Pitt Street South OSD

SOLAR ACCESS
SUBMISSION - 2

26 March 2021
Final

IPC Request - 11 March 2021 (for context)

Stage 2 Detailed Application

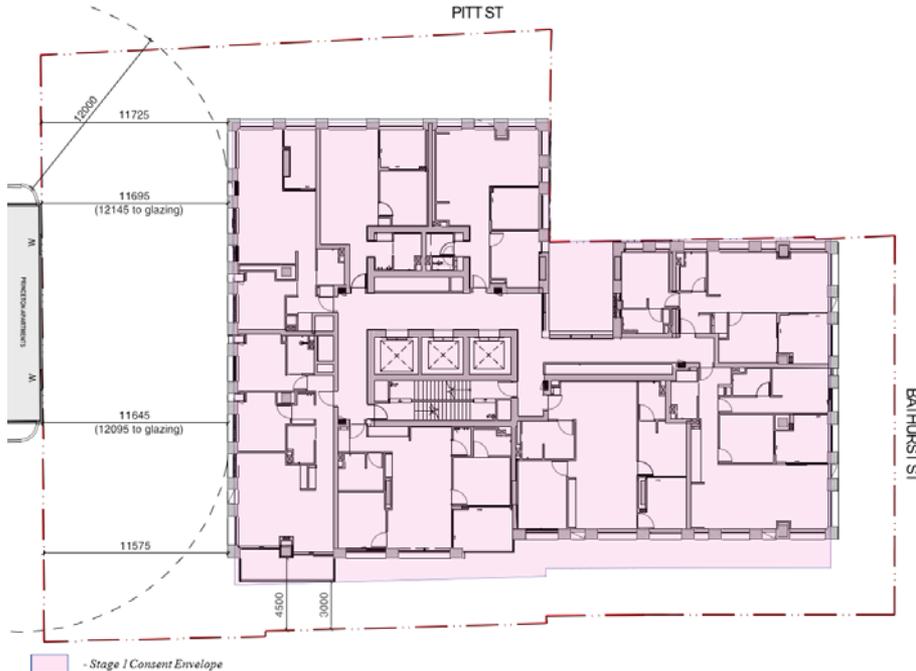
An improvement of **156** Minutes against the Stage 1 baseline is achieved.

- the increased setback to the eastern boundary (from 3.0m to 4.5m) initiated by the Applicant
- the reduction and setback of the podium to the western boundary initiated by the Applicant

Stage 2 Detailed Application – Revised

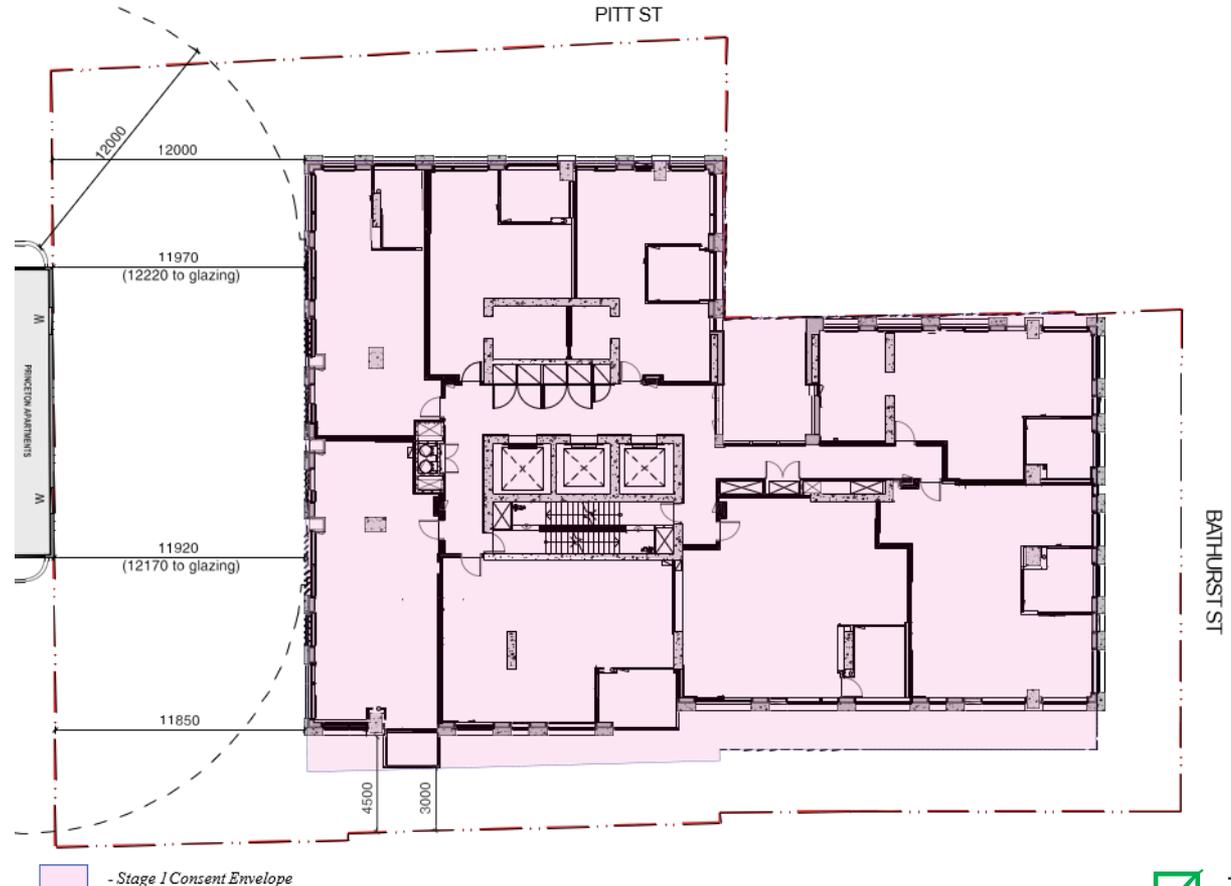
This resulted in an improvement of **168** Minutes against the Stage 1 baseline.

- the increased setback to the eastern boundary (from 3.0m to 4.5m) initiated by the Applicant
- the reduction and setback of the podium to the western boundary initiated by the Applicant
- structural redesign facilitating a floor plate width reduction which allowed for an increased setback to the east

Study 2 – Increase western setback at corner

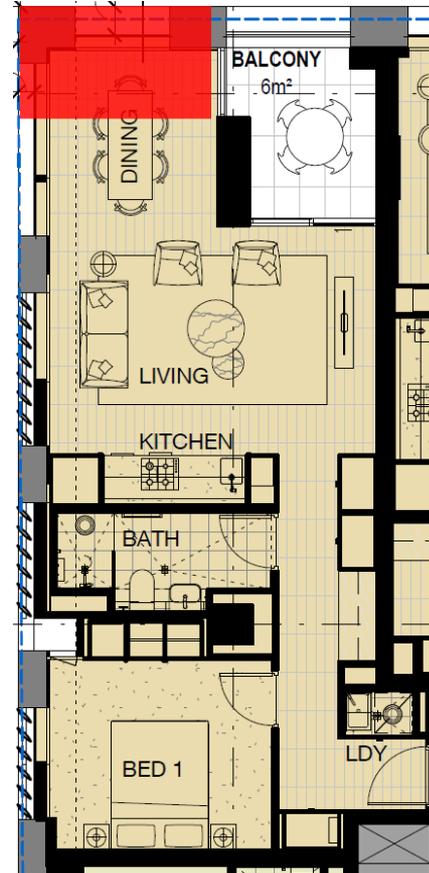
- Increase setback in the south western corner by 1.5m from 4.7m to 6.2m and a width of 2.84m

- No improvement to Compliance
- Increase of 5 Minutes to living areas of 9 apartments i.e. 45 Minutes in total

- Loss of Compliance to 20 apartments, taking Compliance down to 41%

- The integrity of the architectural design of the building is compromised as the building does not hold the corner
- This setback increase is consistent with the depth of the setback to the east verses the Stage 1 approval
- This increases Princeton's solar access by 45 Minutes but pushes 20 OSD apartments into non Compliance.
- Any option to swap the balcony with the dining room also pushes 20 OSD apartments into non Compliance

Study 4 – Remove balcony to south east corner

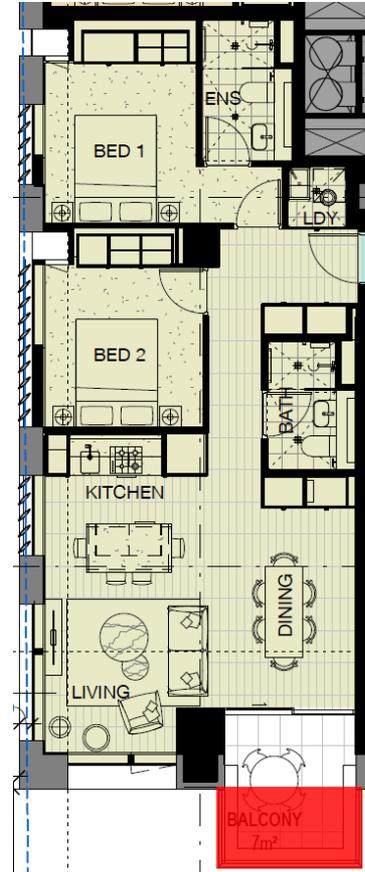
- Remove balcony to south east corner apartment

- No improvement to Compliance
- No improvement in Minutes

- Not viable as no benefit is provided to Princeton Apartments and results in an amenity reduction to the south east corner apartment
